Technical Bulletin

Model: Russian-C2 Da				te : 24-Oct-01	No.: RB022001
Subject: The fax function does not work				Prepared by: S.	Tomoe
From: Technical					
Classification:	Troubleshooting	Part info	orma	tion Actic	on required
	Mechanical	Electric	al	Serv	ice manual revision
	Paper path	🗌 Transm	iit/rec	eive 🗌 Retro	ofit information
	Other ()

Model: Russian-C2 D			Dat	e: 11-Jun-02	No.: RB022014
Subject: Rear Co	over	Prepared by: S.	Tomoe		
From: Technical Services sec. Service Planning Dept.					
Classification:	Troubleshooting	Part inf	ormat	tion 🗌 Actio	n required
	Mechanical	Electric	al	Servi	ce manual revision
Paper path Transmit		it/rec	eive 🗌 Retro	ofit information	
	Other ()

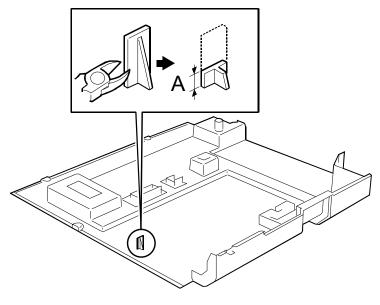
Symptom

A rib on the Rear Covers produced at the factory in Korea (for machine code: B022-57) contacts the FCU bracket and prevents the cover from being installed. **Note:** Service parts are unaffected, as they are produced in Japan.

Cause

The manufacturer had used the mold for the Russian-C1 to make the Rear Cover (which normally contains the rib).

Permanent: The manufacturer will ensure that the proper molds are used for both covers.

Action in the field: When installing the optional fax unit, please cut the rib off as shown in the illustration below.

A: 0 – 3 mm
